Amendment #2 -- Briggs Avenue Extension

**Durham-Chapel Hill-Carrboro Metropolitan
Planning Organization**
Comprehensive Transportation Plan
December 9, 2020

Amendment #2 – Delete Briggs Avenue Extension (December 9, 2020)

DCHC MPO Comprehensive Transportation Plan Amendment #2 -- Delete Briggs Avenue Extension

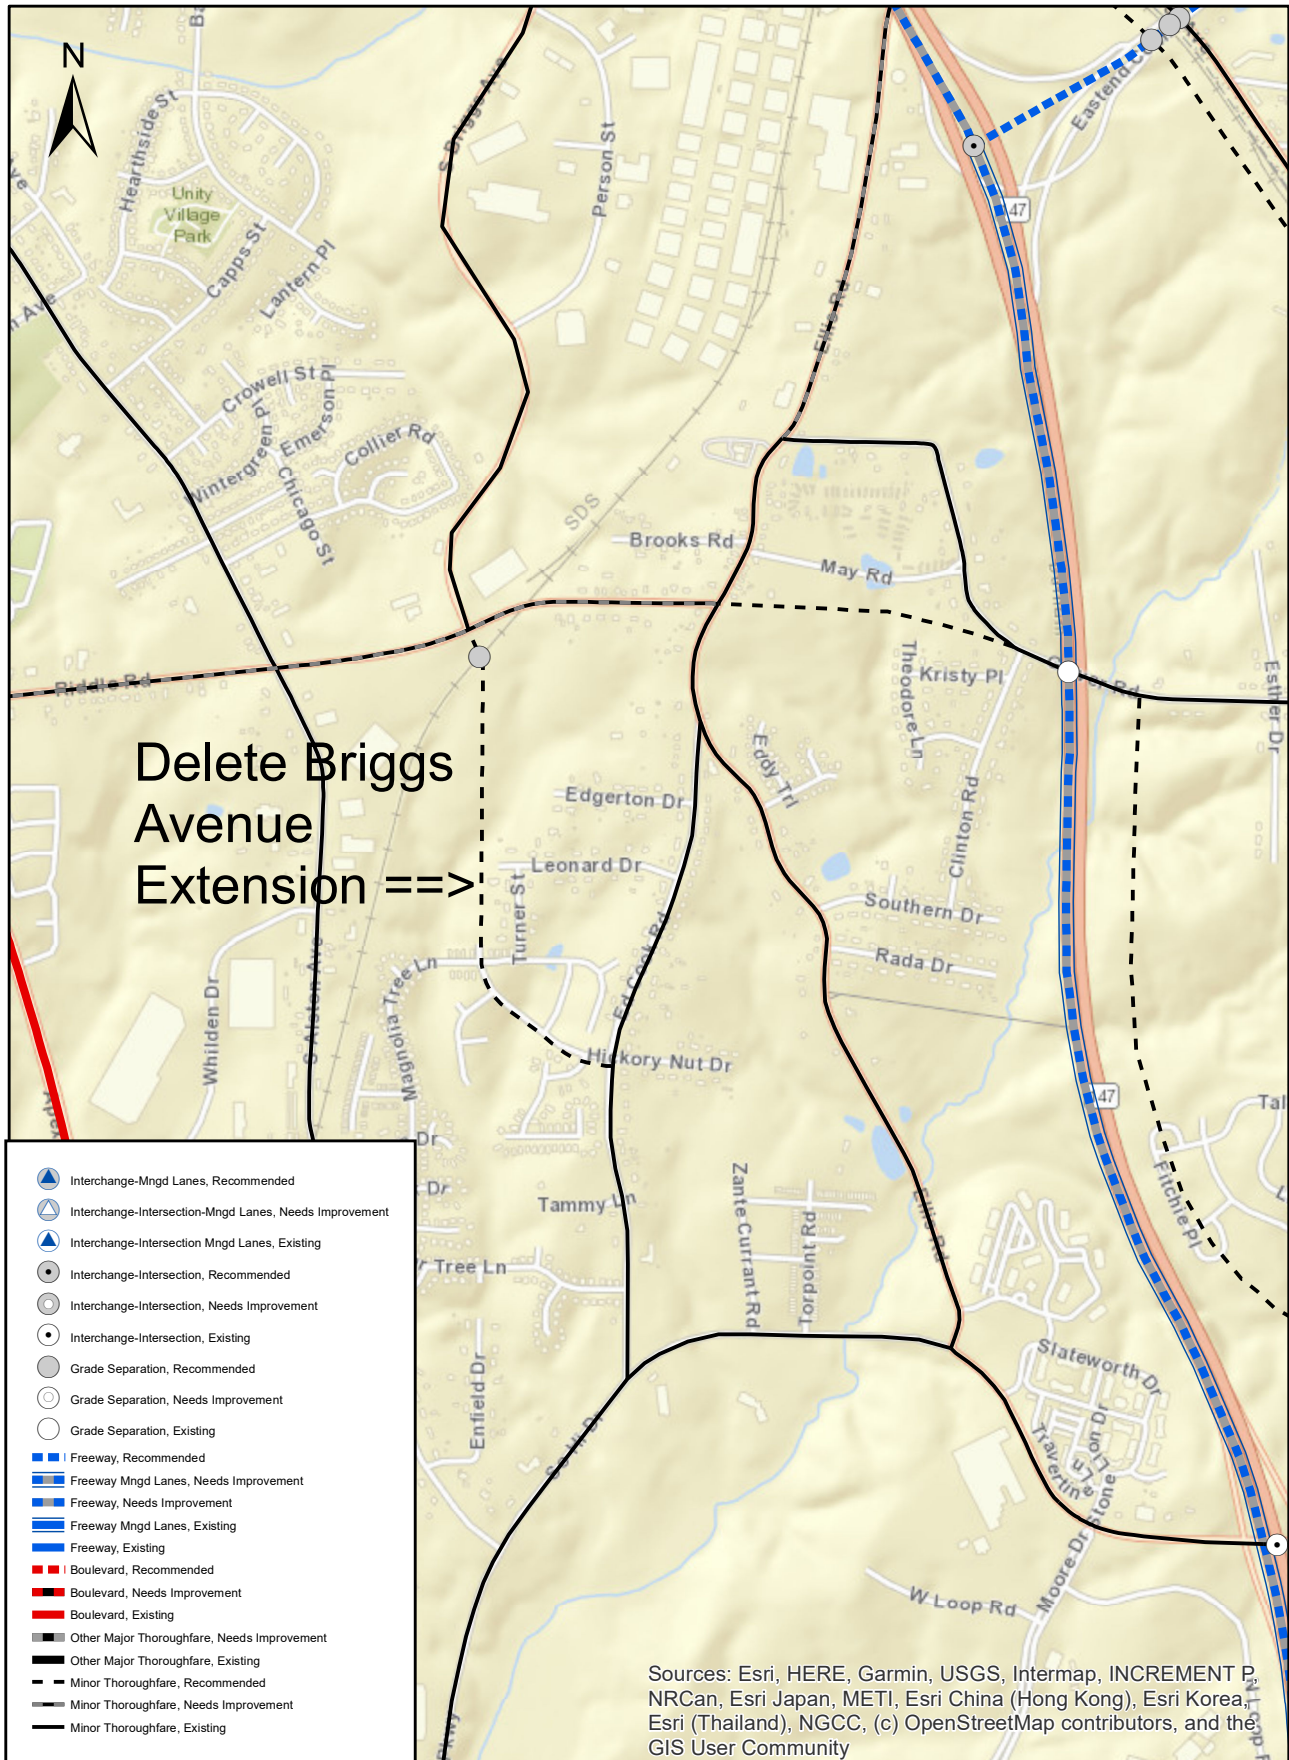
The Durham-Chapel Hill-Carrboro Metropolitan Planning Organization (DCHC MPO) hereby amends the Comprehensive Transportation Plan (CTP) to delete the proposed Briggs Avenue Extension from Riddle Road to Ed Cook Road. The CTP highway map on page 3 shows the roadway segment that is to be deleted.

Map -- The official CTP map deletes the Briggs Avenue Extension. See map on page 3
